FED. ROAD DIST. NO.	STATE	FED. AID PROJ. NO.	FISCAL YEAR	SHEET NO.	TOTAL SHEETS
HAWAII	HAW.	BR-STP-056-1(35)	2000	C.O. 17	70

WAIKAEA BRIDGE WIDENING

KUHIO HIGHWAY-WAIKAEA BRIDGE WIDENING
Fed. Aid Proj. No. BR-STP-056-1(35)

PARTIAL PLAN
(SHOWING LIMITS OF GRP AT END POST NO. 3)
Scale: 3/8"=1'-0"

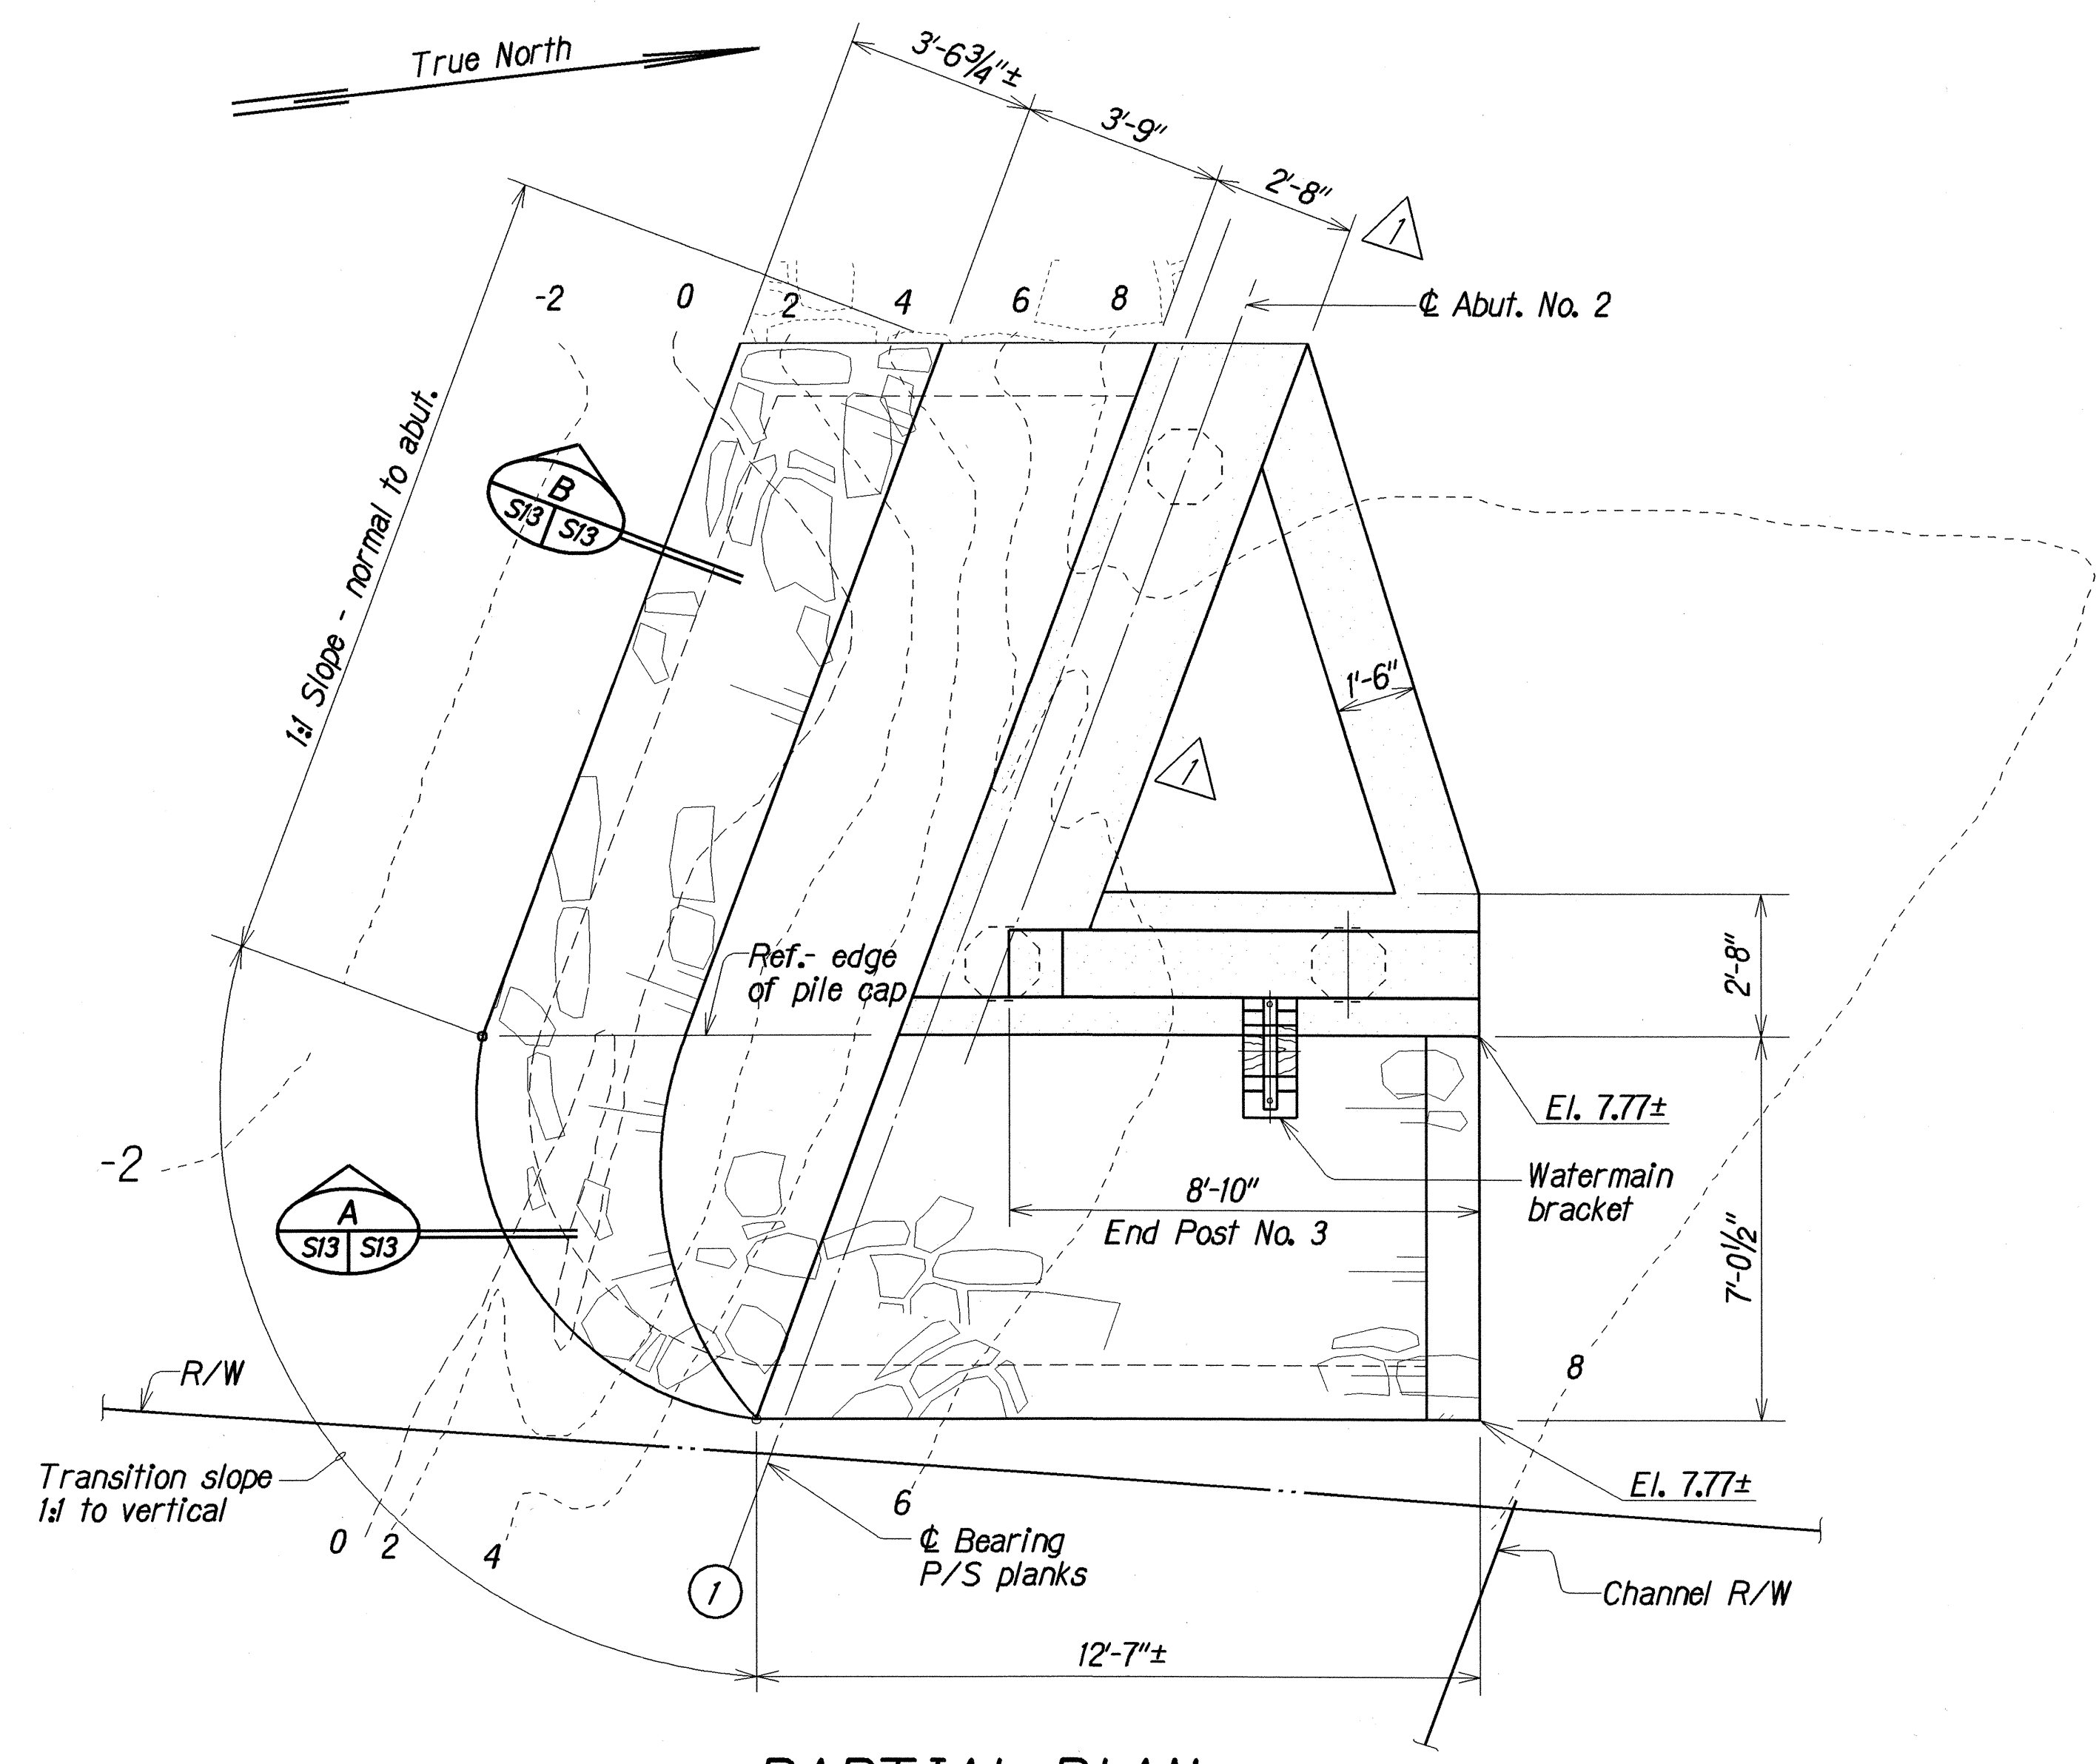
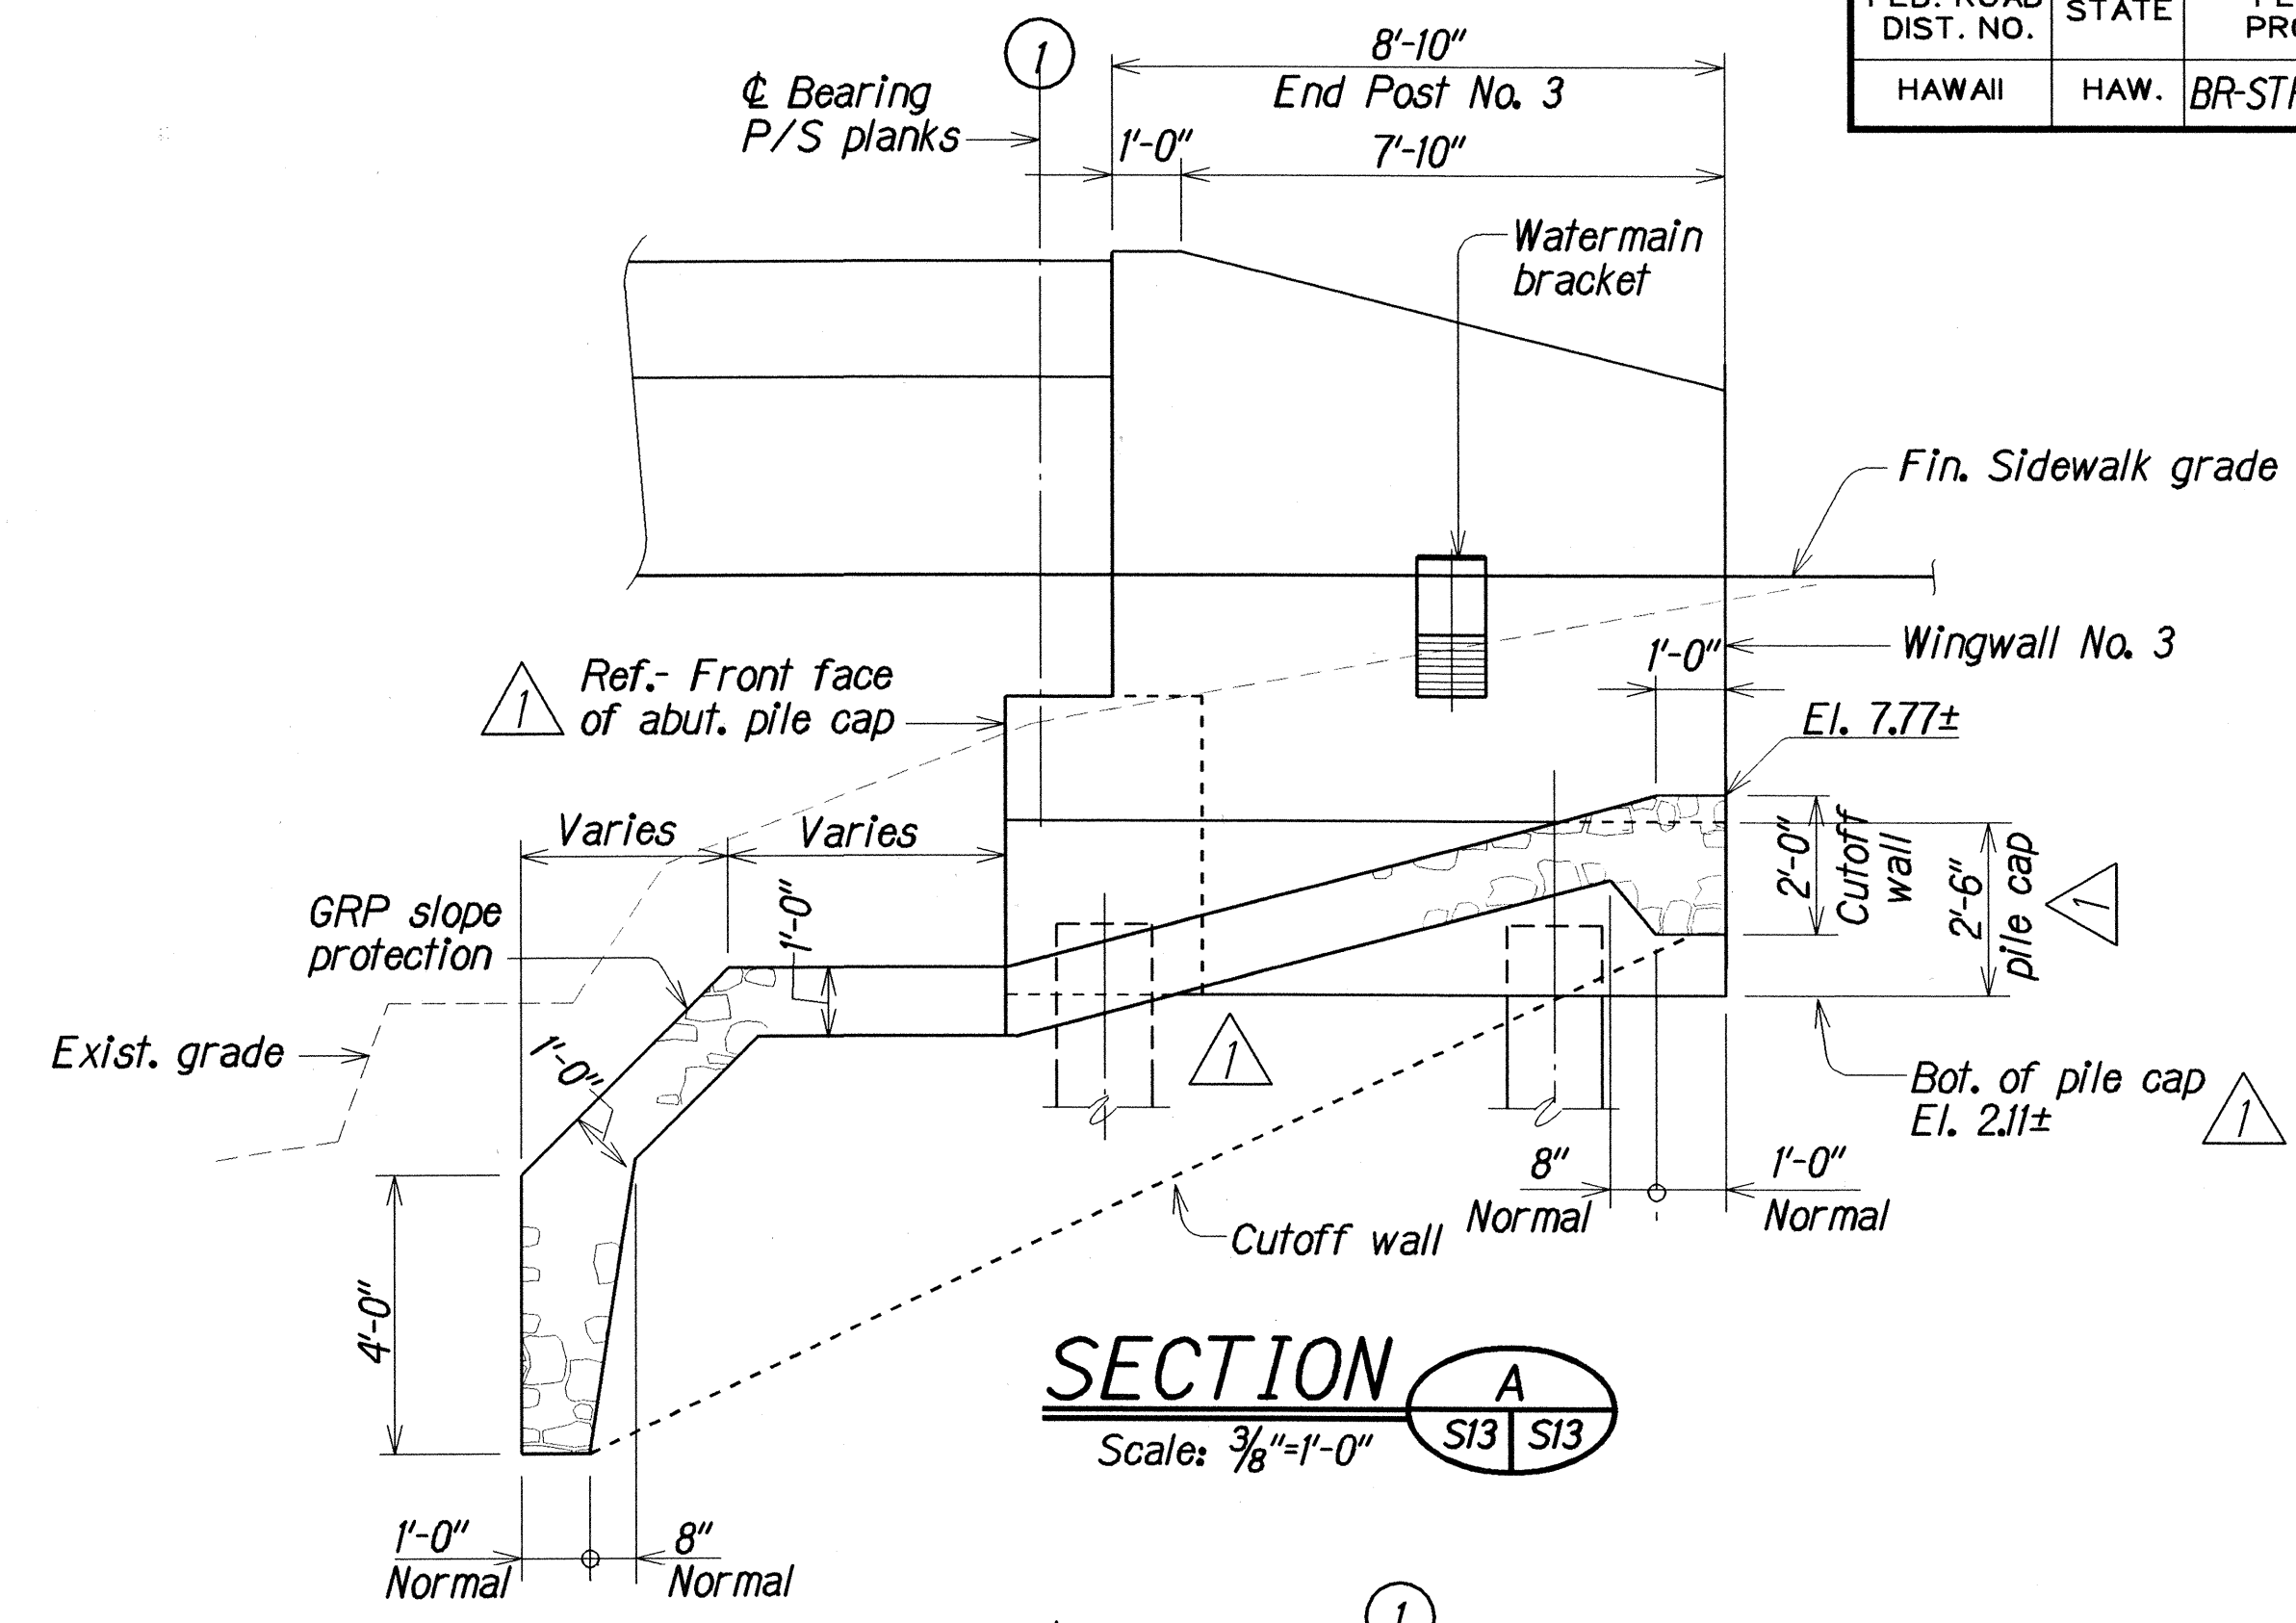
1
6/6/01
Bot. of abut. pile cap elevation changed. Piles, bridge, wingwall & abut. pile cap, lowered to accomodate changes. GRP removed behind front face of abut. pile cap. Labels moved and changed for clarity. Note #1 added.
